ADDENDUM NO. 1

RFQ CCC-078

**Administration Building Renovation
Compton Community College District**

tBP Project. No. 20987.00

1. Revised SHEET AS-2 SITE DETAILS AND ACCESSIBLE PARKING

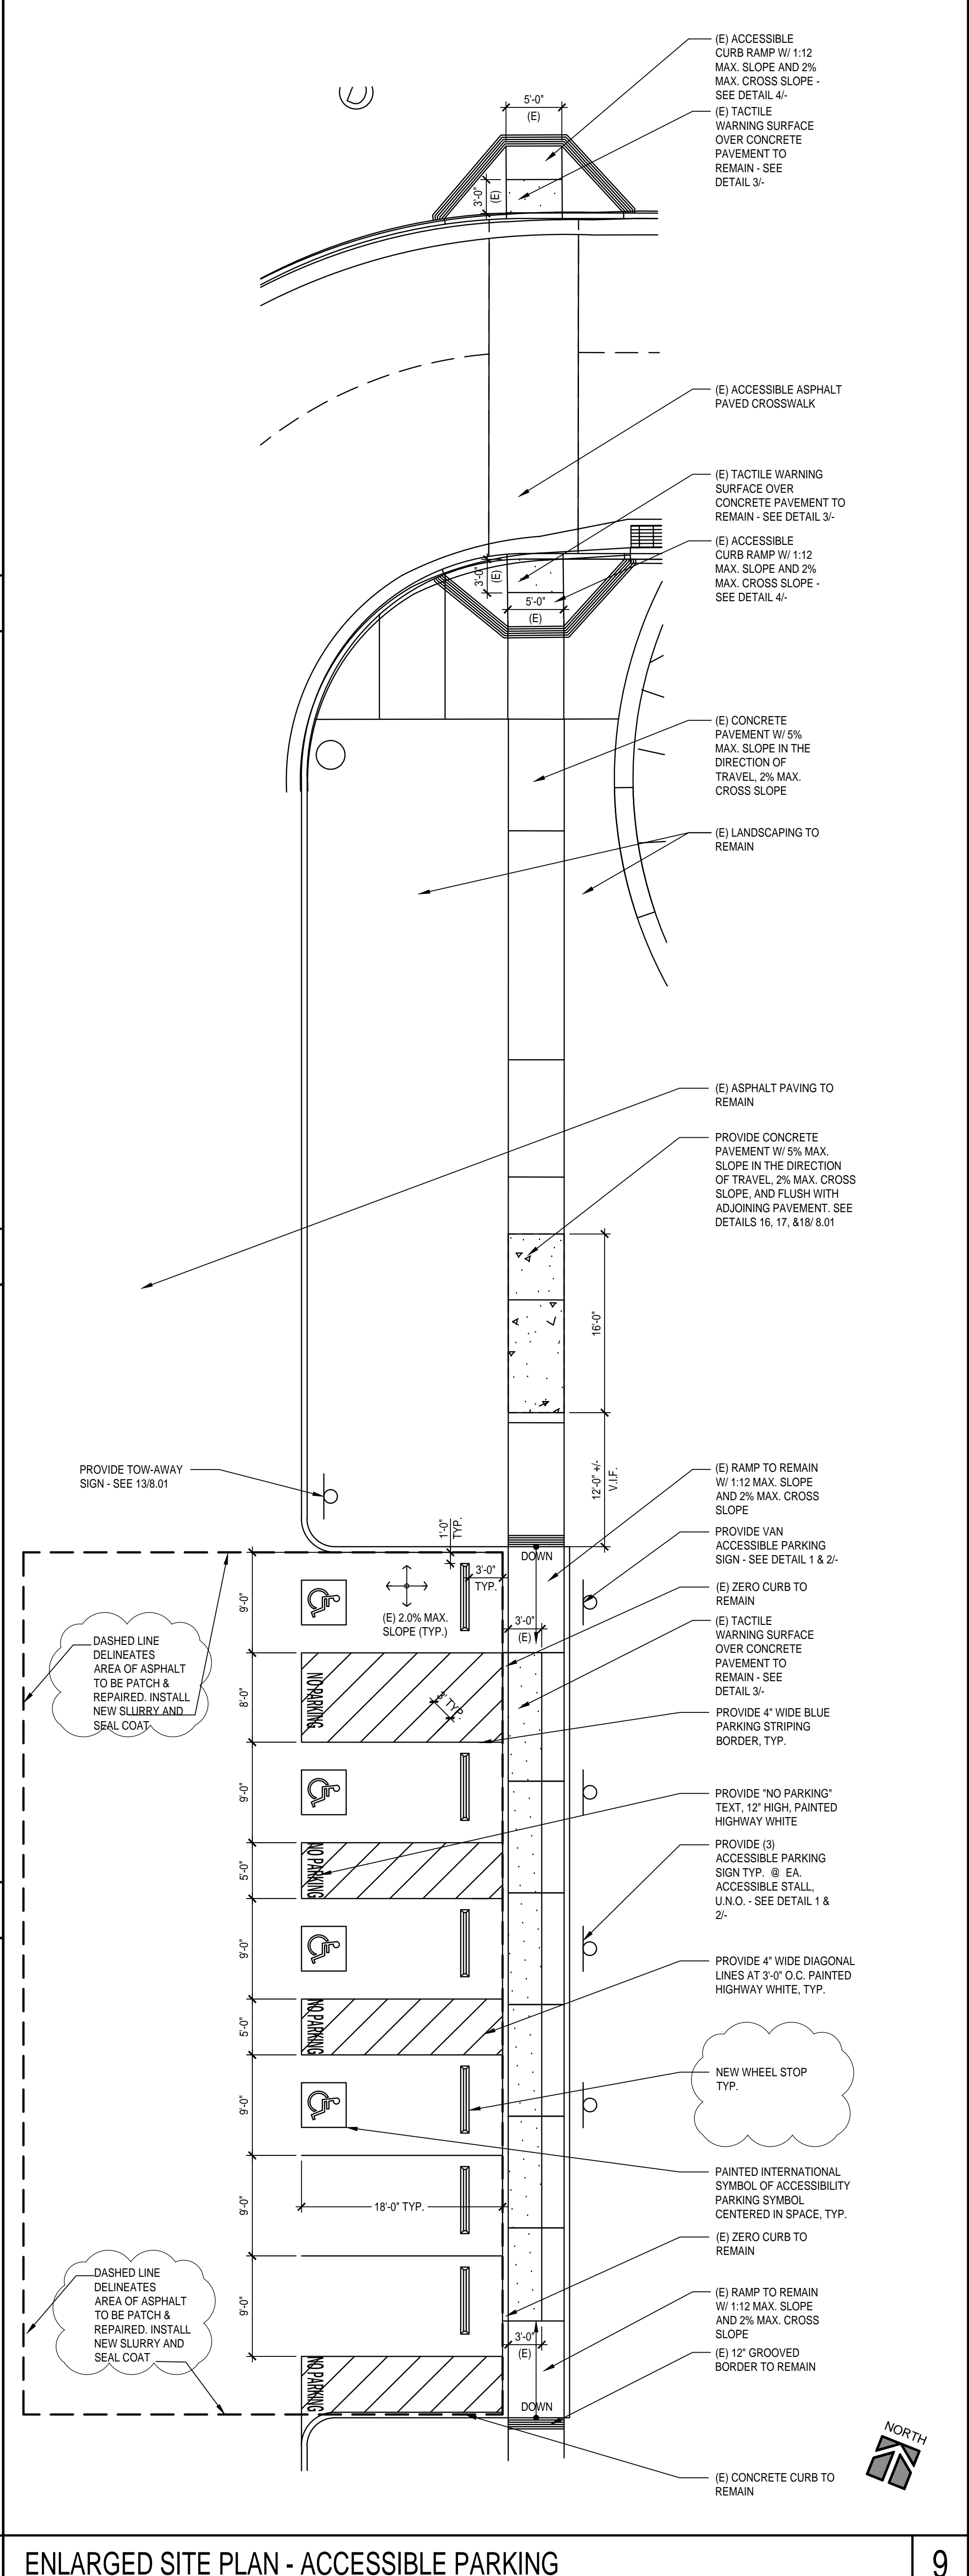
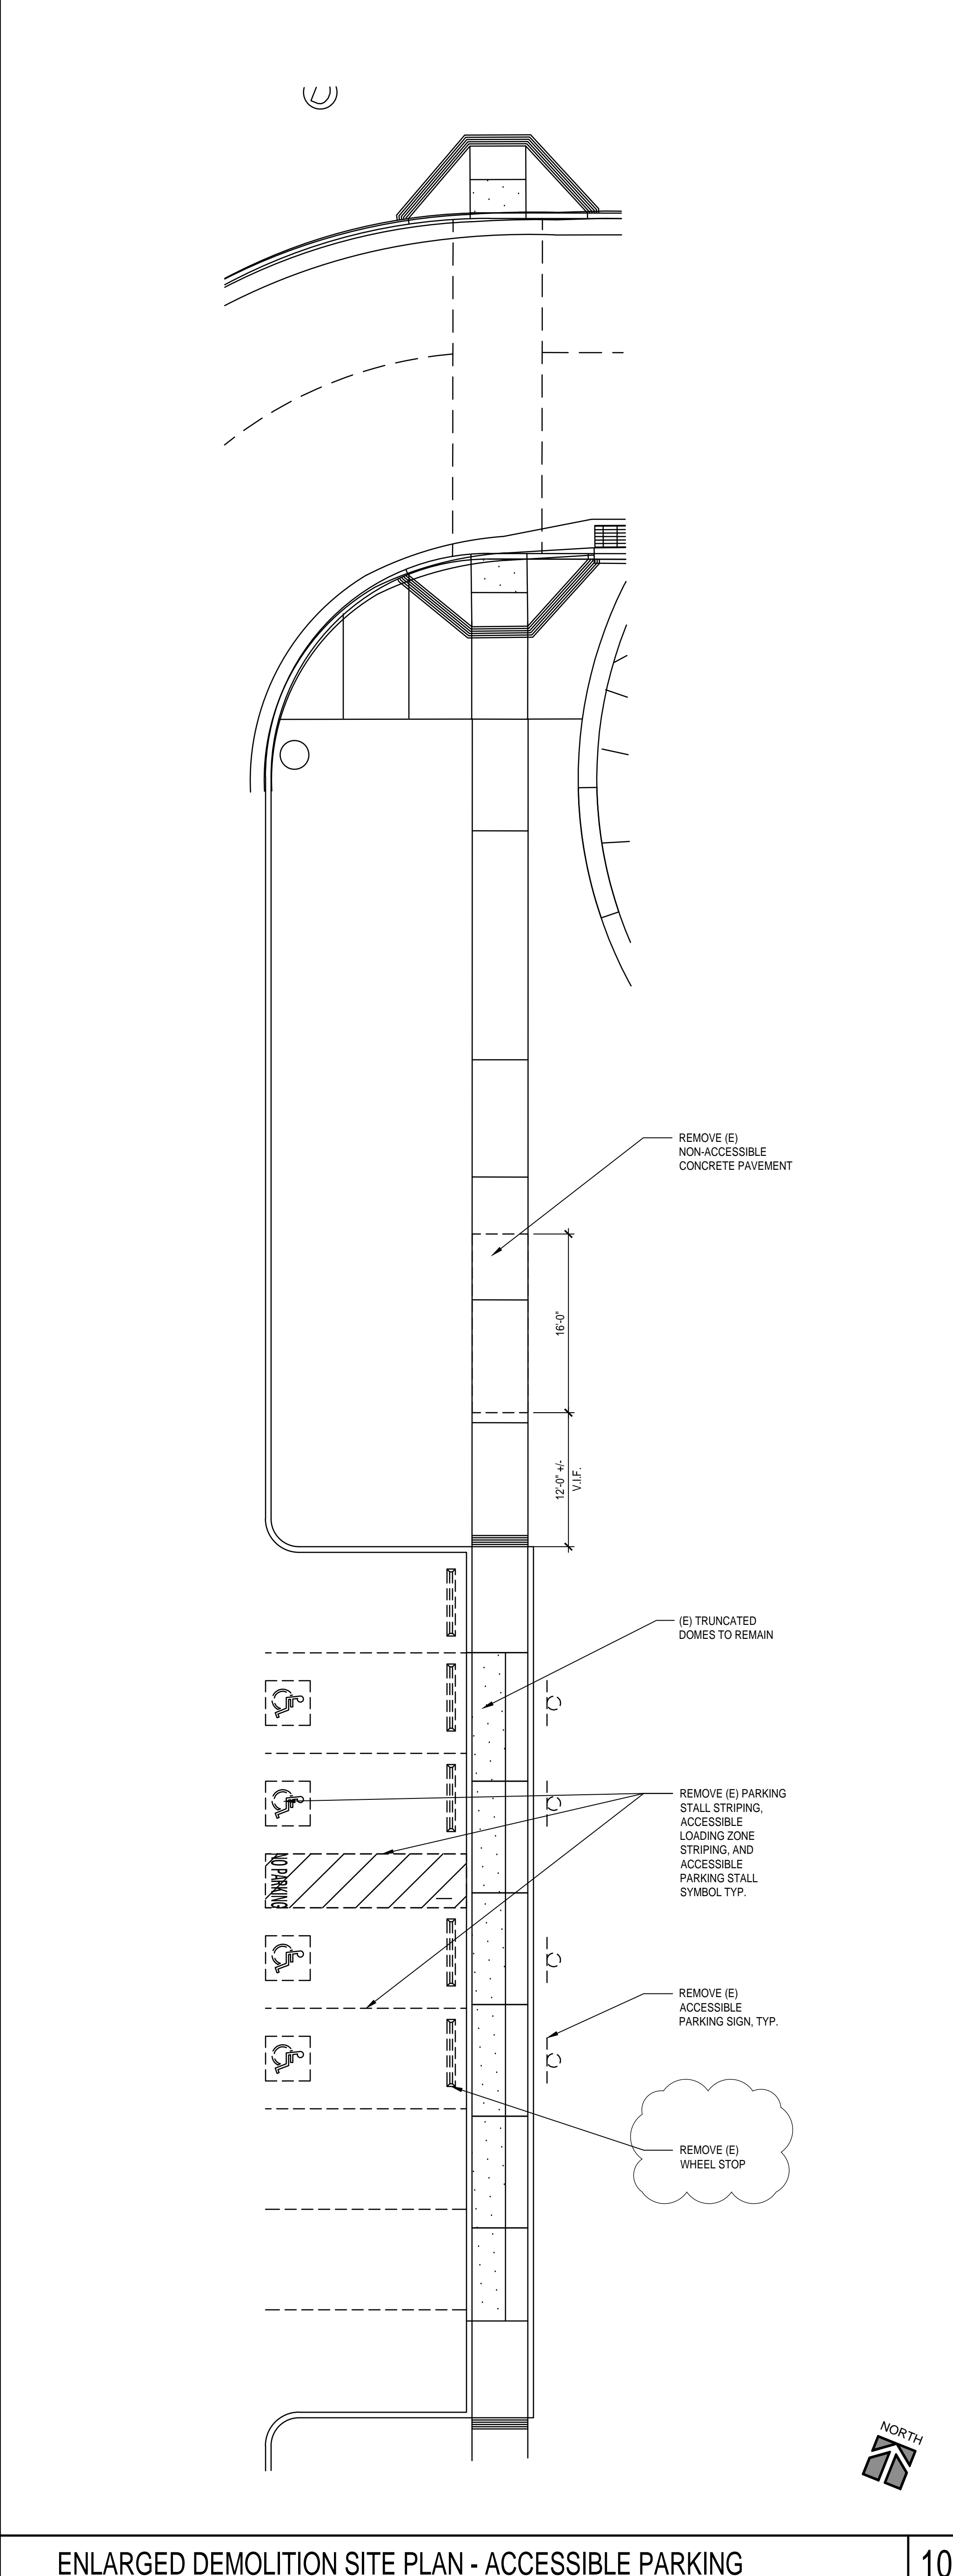
a. Included repair and slurry of asphalt area where new ADA parking is re-

- stripped.
- b. Revised all existing wheel stops to be new.
- c. Corrected detail references.
See attached revised Full size sheet identifying revisions included as part of this addendum.

2. **Revised SHEET A0-1 FLOOR PLANS DEMOLITION.**

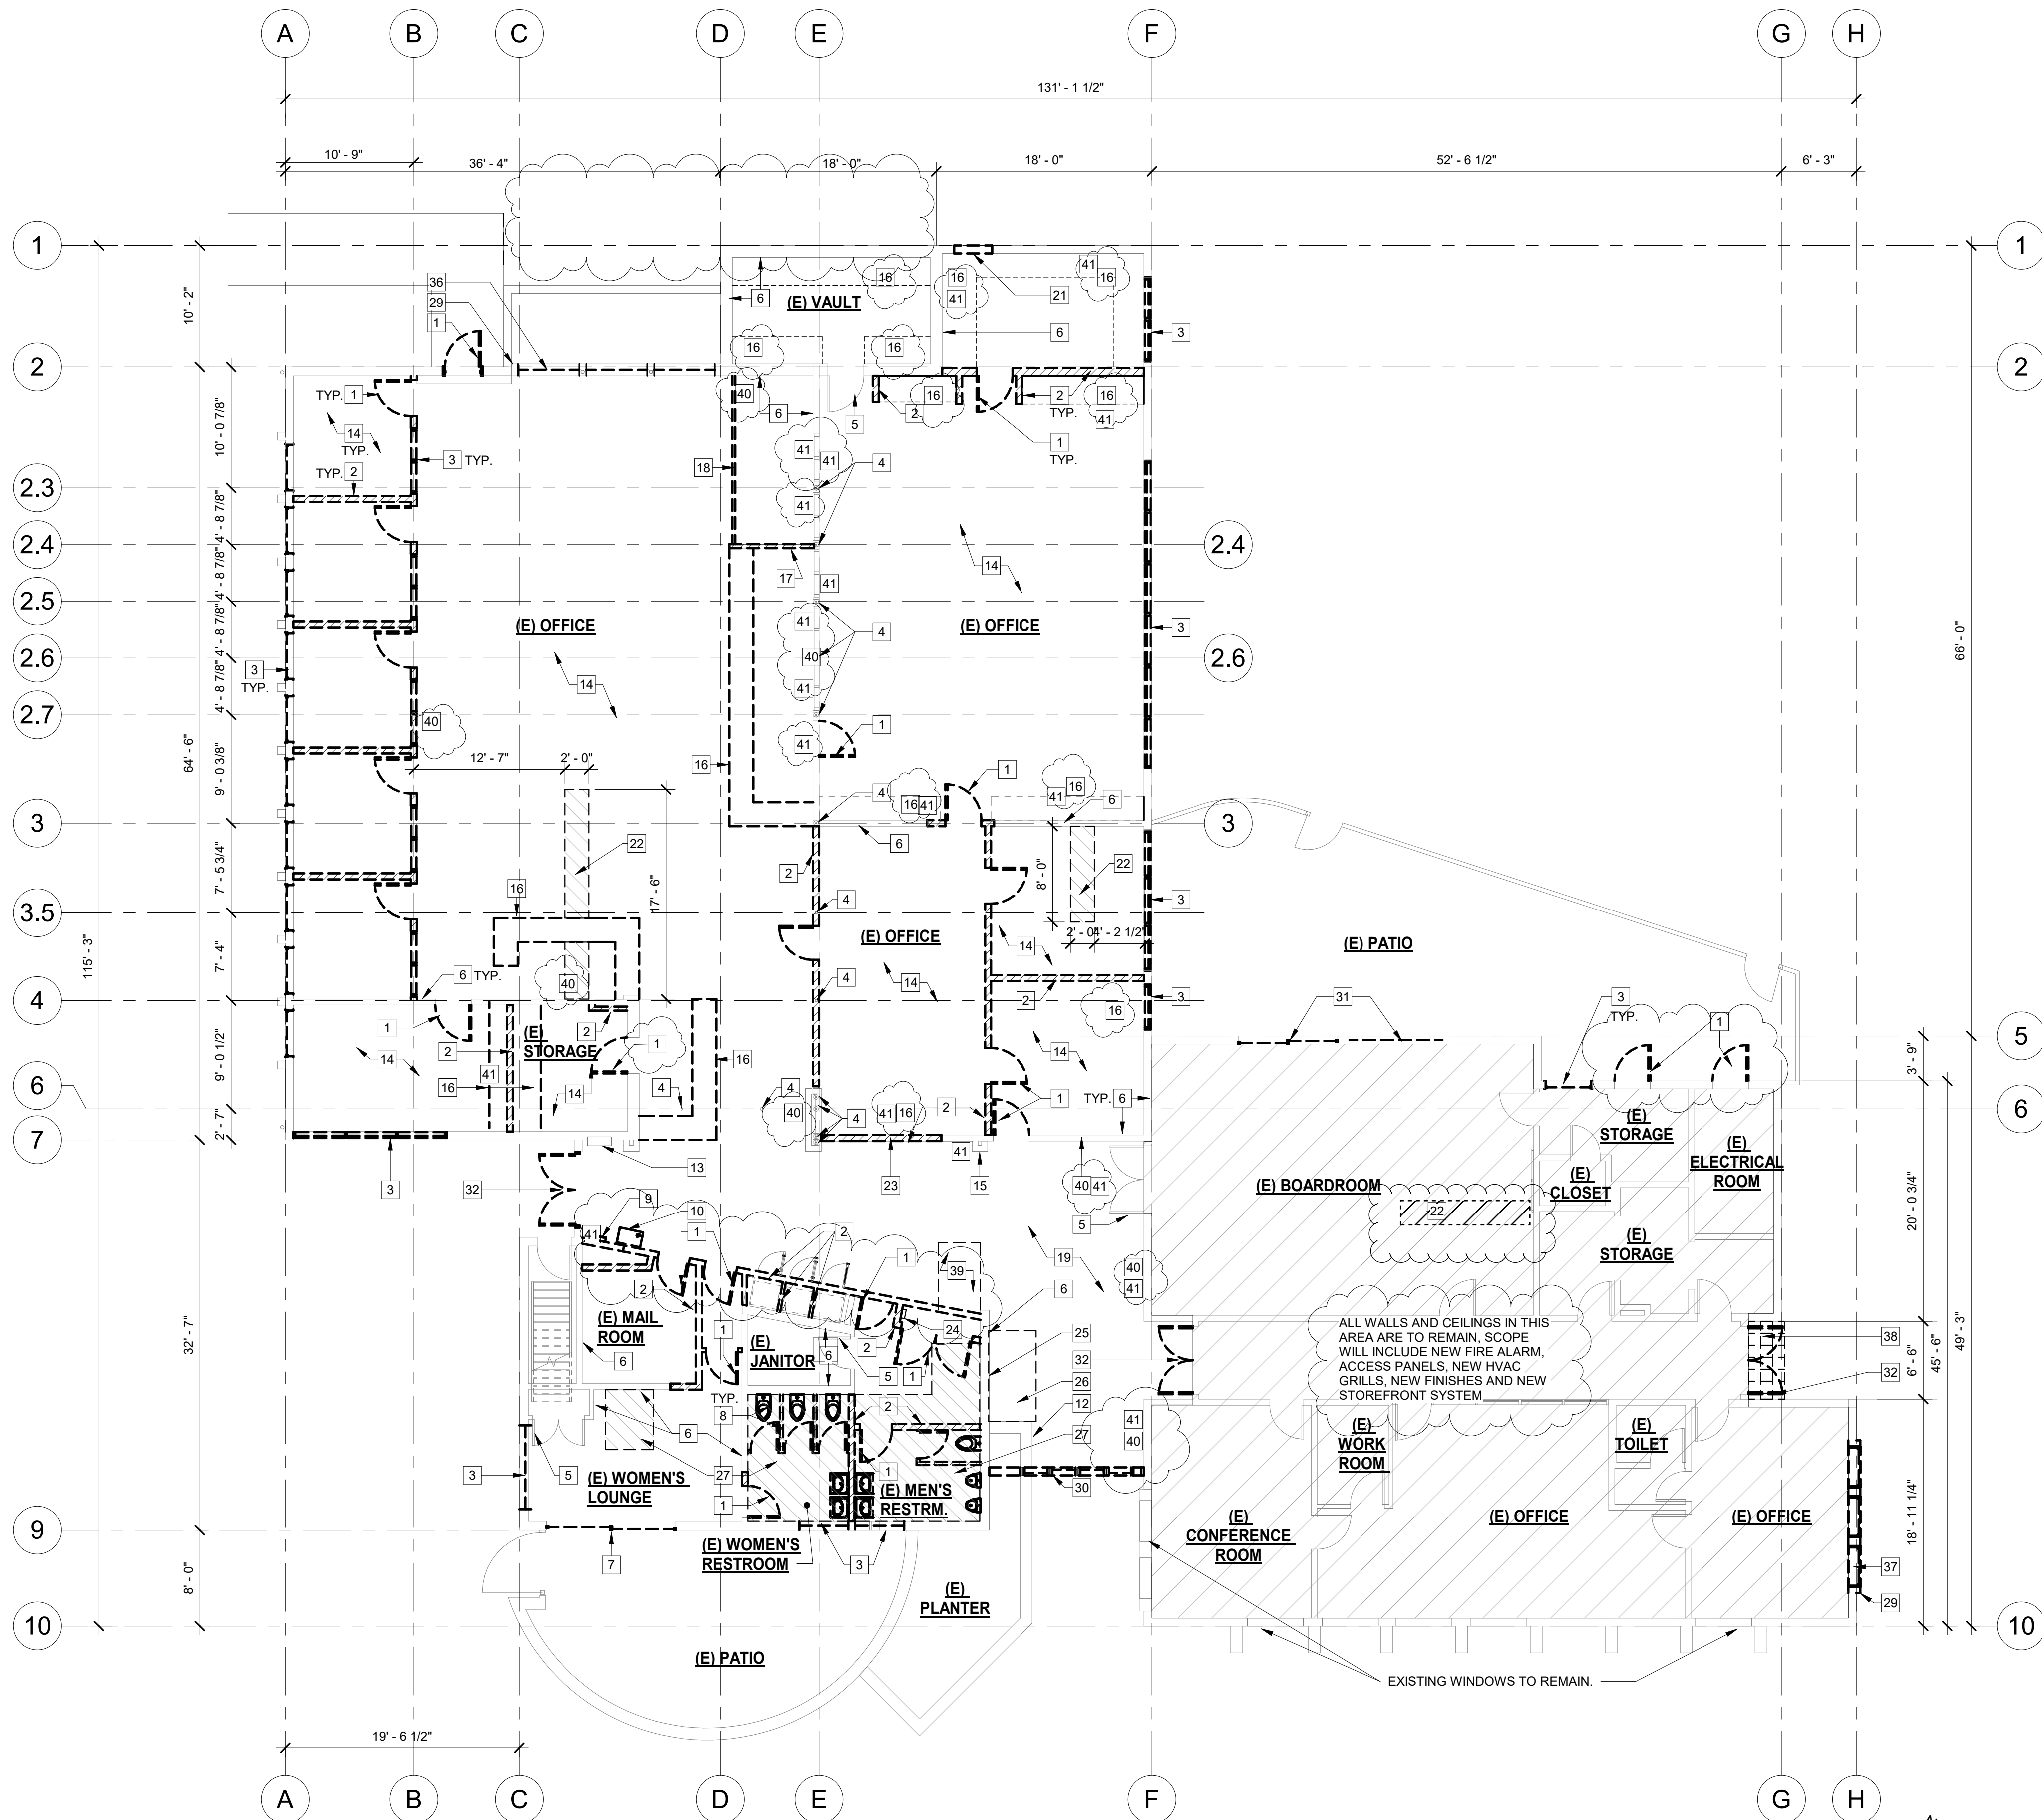
- a. Corrected general notes to clarify ambiguous scope notes.
- b. Include the replacement of two existing damaged exterior doors in the Electrical room and Storage room.
- c. Included the replacement of a wood window systems affected by termites.at the east side of the building.
- d. Added the demolition of the Lobby south wall (original building phone booths) and relocated new DF to this alcove created at this location.
- e. Added note 16 in several places where there were missing.
- f. Revised Key notes 13, 25, 29 and 37 Added key notes 39, 40 AND 41.
- g. Corrected graphics for wall to be remained shown as demo at grid line 2.
- h. Omitted the removal of the exterior sidewalk at the north side of the building.
- i. Added note and scope 22 to the existing boardroom.
See attached revised Full size sheet identifying revisions included as part of this addendum.
